From: Melinda Hamilton <[REDACTED]>
Sent: Monday, November 8, 2021 7:51 AM
To: PlanningCommission AP
Subject: neighborhood concerns about 490 Mathilda project
Attachments: [item 1-480 Mathilda Office Project Description \(8-17-21\) MINKOFF EDITS FINAL.docx](#); [item 2-actual corner small.jp2](#); [item 4-Final PRC Letter 2021-7280 \(5-26-21\).pdf](#); [item 5-2021-7280_490 S Mathilda - Plan Check City Comment responses.pdf](#)

RE: 490 S. Mathilda Ave
 Address: 490 S. Mathilda Ave, Sunnyvale, CA

Attention: **Shaunn Mendrin**
Principal Planner

SK-01 - PARKING GARAGE ENTRANCE RAMP

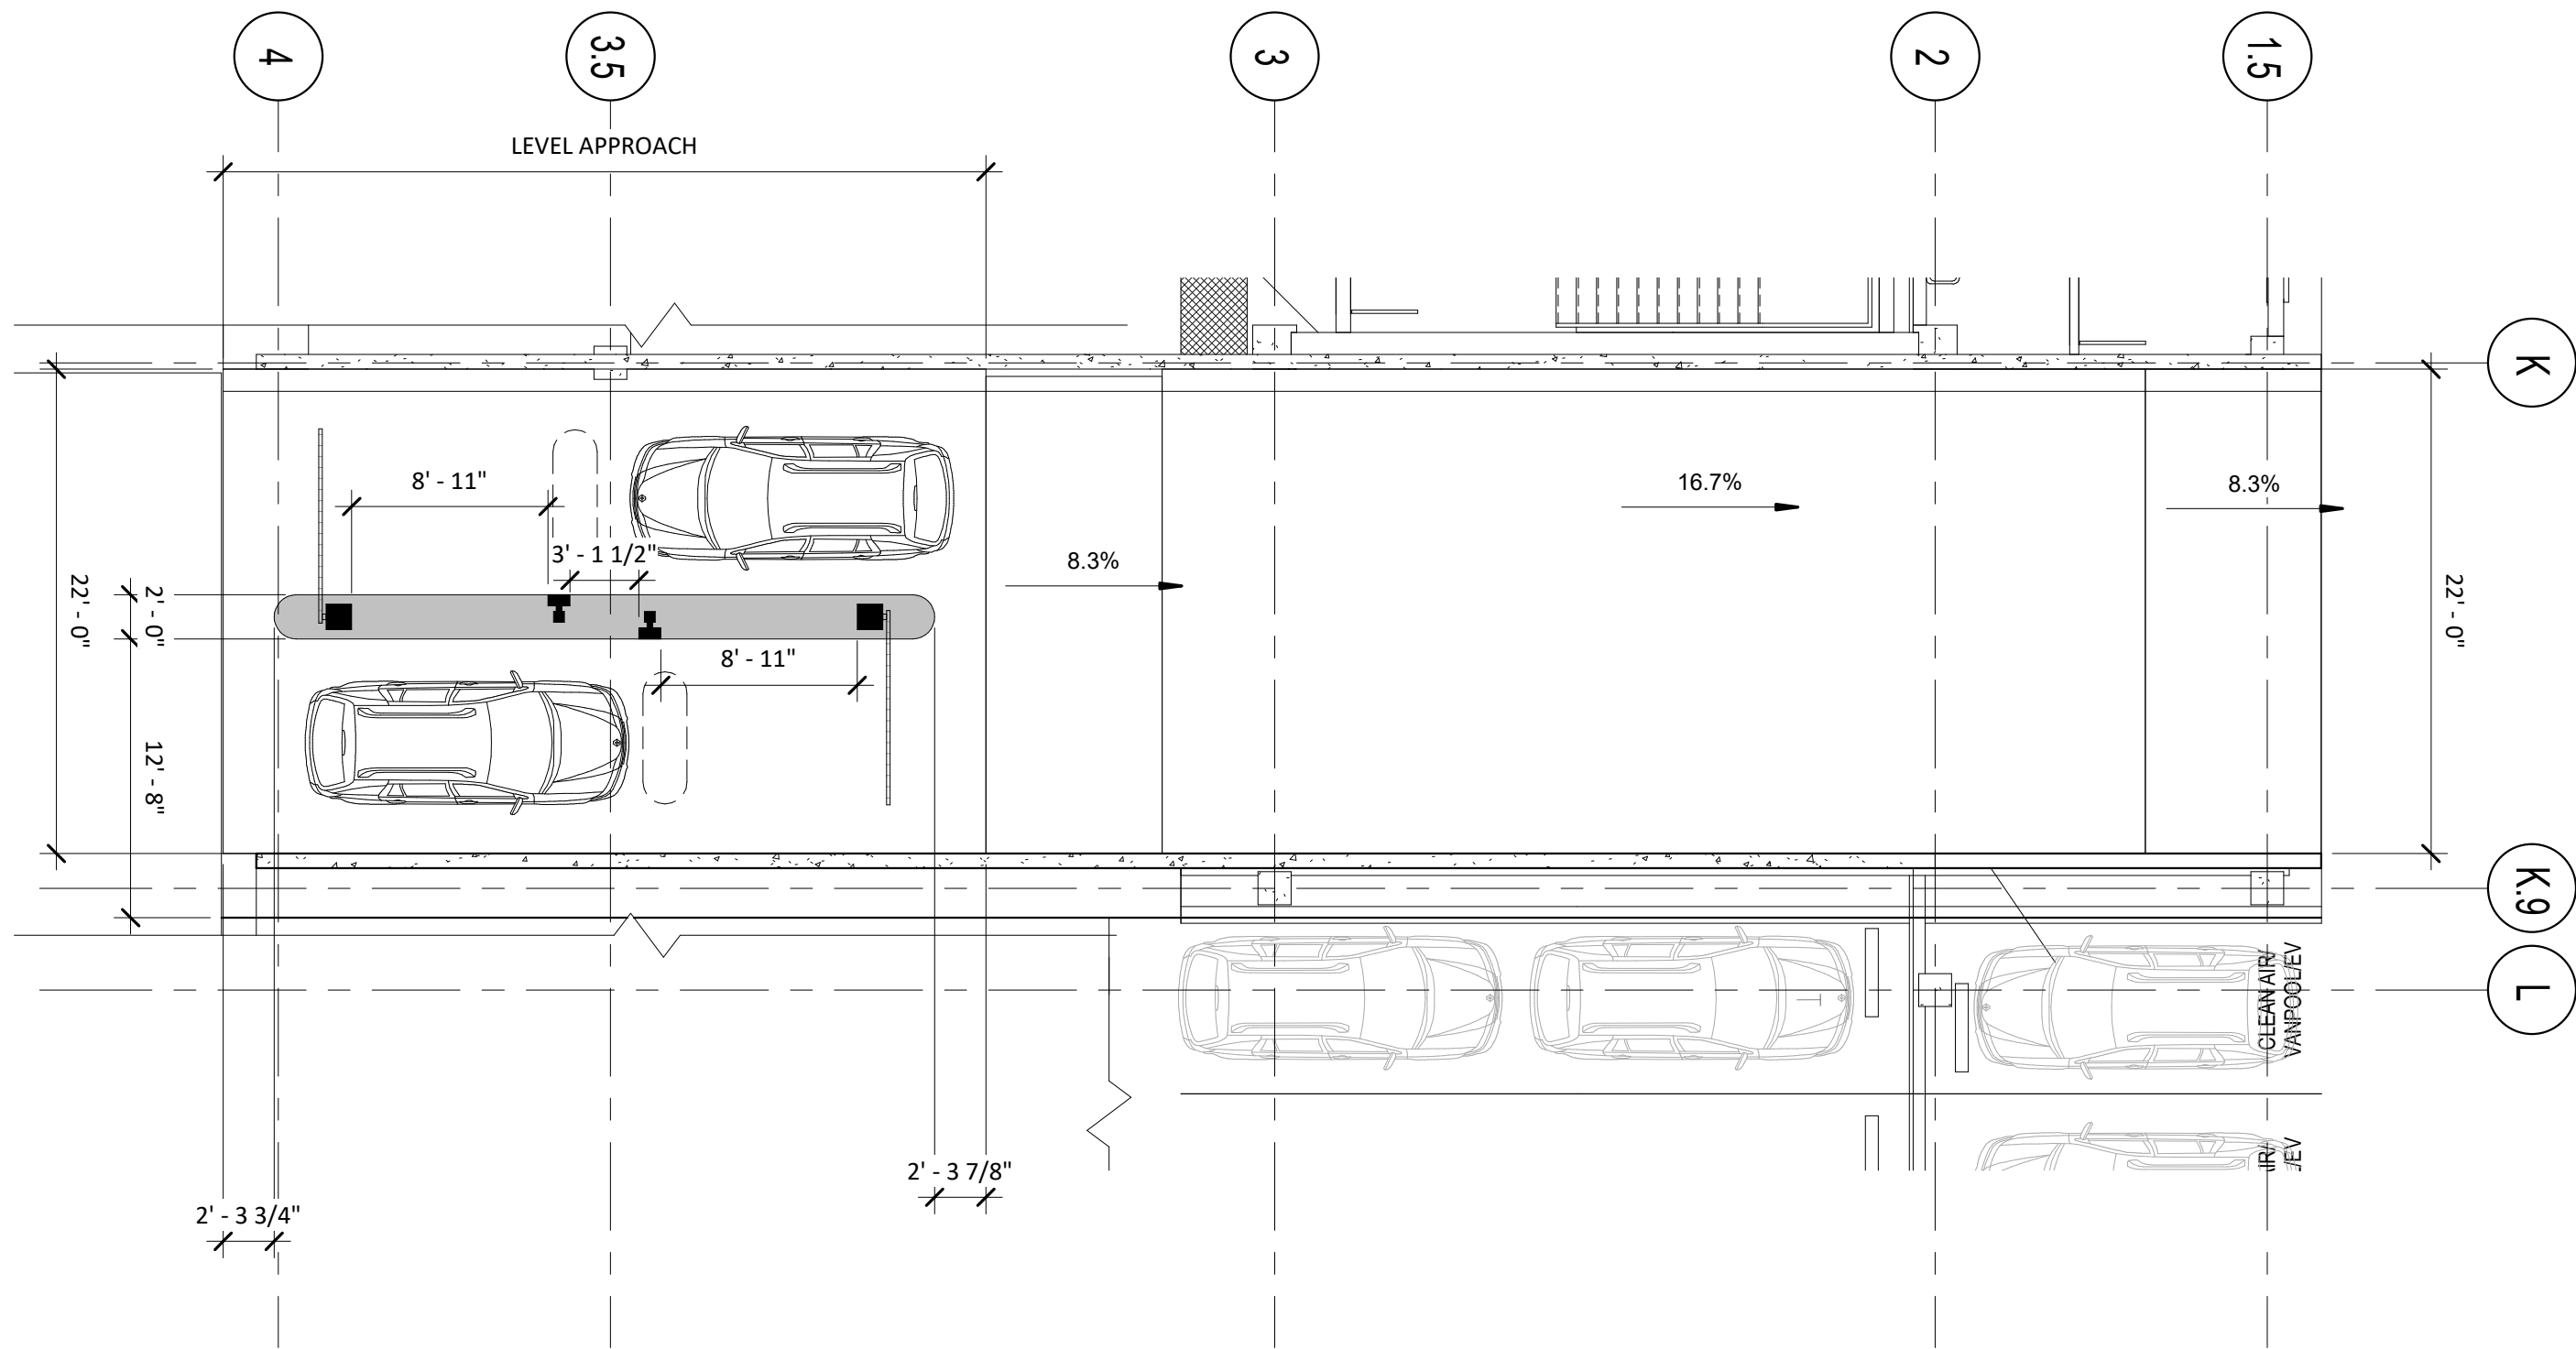
1.5	A2.01, .02 & .11	<p>d) Provide clear dimensions for the standard parking spaces.</p> <p>e) Garage ramp slopes should not exceed 12%</p>
		<p><i>Response:</i></p> <p><i>d. Standard parking stall diagram is shown on A2.01 and A2.02.</i></p> <p><i>e. Given the frequency of below grade construction, the limitation of site geometries and other constraints; the ramp slopes (for non-parking ramps) are sloped greater than 12%. Other jurisdictions near Sunnyvale (i.e., San Jose and Palo Alto) allow up to 20% to 22% slope for non-parking ramps. The Sunnyvale project at Altair has been approved with non-parking ramps of 20% slope.</i></p> <p><i>It is our opinion that shallower ramp slopes at the entrance to and exit of the garage are desirable for reducing speeds on ramps and improving visibility for drivers of potential on-coming traffic and/or pedestrian crossings.</i></p> <p><i>For the 490 Mathilda project, our recommended slope exceeds the 12%, for the bulk ramp within the footprint of the building but given the setback to the property line and back of walk we are proposing to provide ample 'level' surface areas for the exiting vehicles to acclimate to the outdoor environment and give plenty of space for deceleration and improved visibility of any potential pedestrian crossings or conflicts ahead.</i></p> <p><i>Please see the section attached (SK-02) per request, which illustrate this ramp design and allows for enough distance of 'level' approach/exit for motorists so that they can avoid any potential conflicts.</i></p> <p><i>In addition, reducing the slope will increase the ramp length and push the bottom floor of the garage further into the water table. A longer ramp length from Level 1 to B1 would reduce the head height clearance and would not meet code requirements. See notes on section on SK-02.</i></p> <p><i>See attached SK-01, SK-02, and SK-03 to illustrate the above comments.</i></p>

Mathilda Frontage

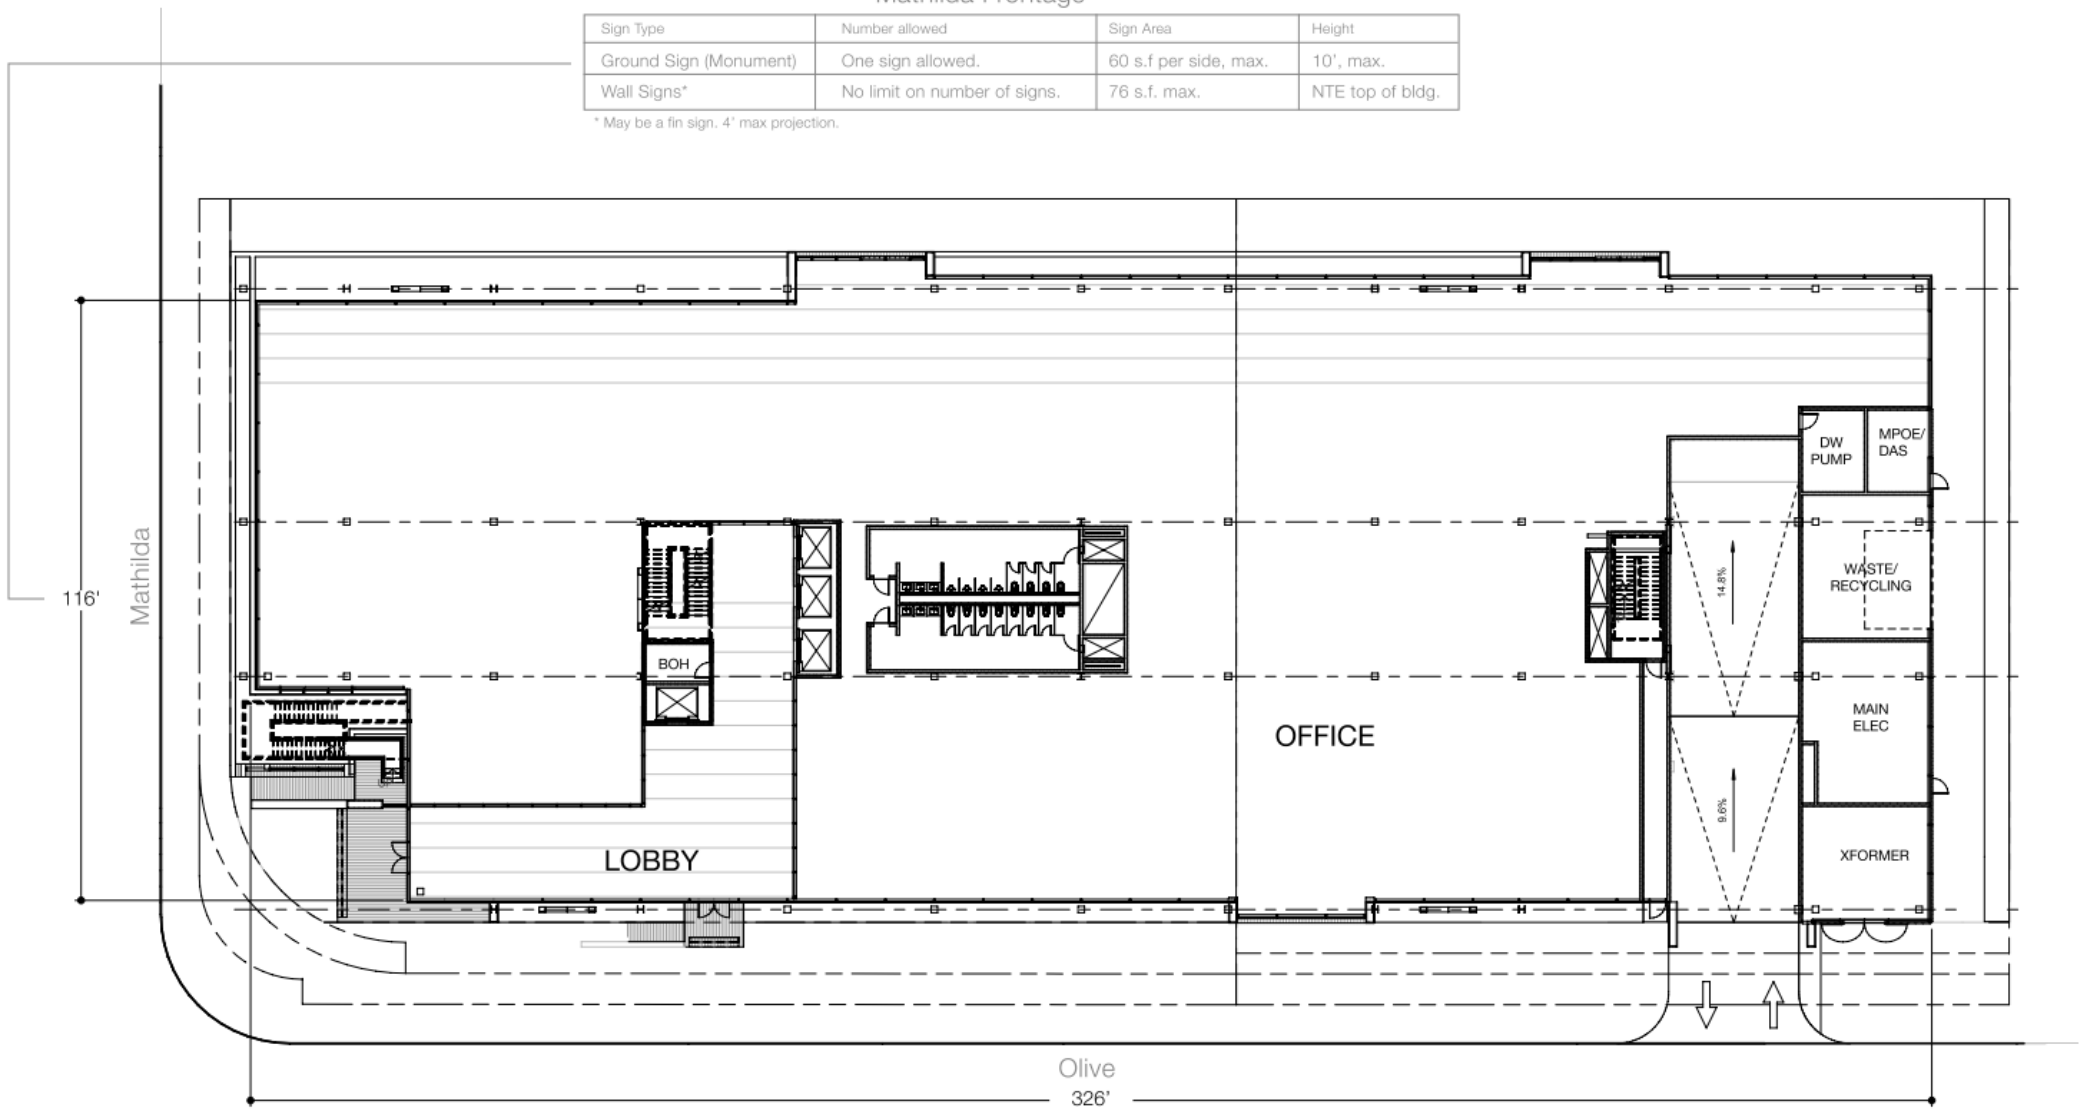
21.		<p>Building signage should be incorporated into the design of the building (GG-E). The sign noted on the elevation appears to be an afterthought.</p>
		<p>Response: <i>See SK-04 for a conceptual design. Final signage design will be included in subsequent submittals prior to building permit.</i></p> <p><i>A location for monumental signage is proposed at ground level near the lobby entry and is integrated into the architecture utilizing the buildings material palette. Signage locations are identified on sheets A2.11 & A3.02. A rendering of the condition is provided on sheet G0.06.</i></p>
		<p><u>Public Works</u></p> <p>Incomplete items - The following items are needed to demonstrate that the proposed project complies with City standards.</p>
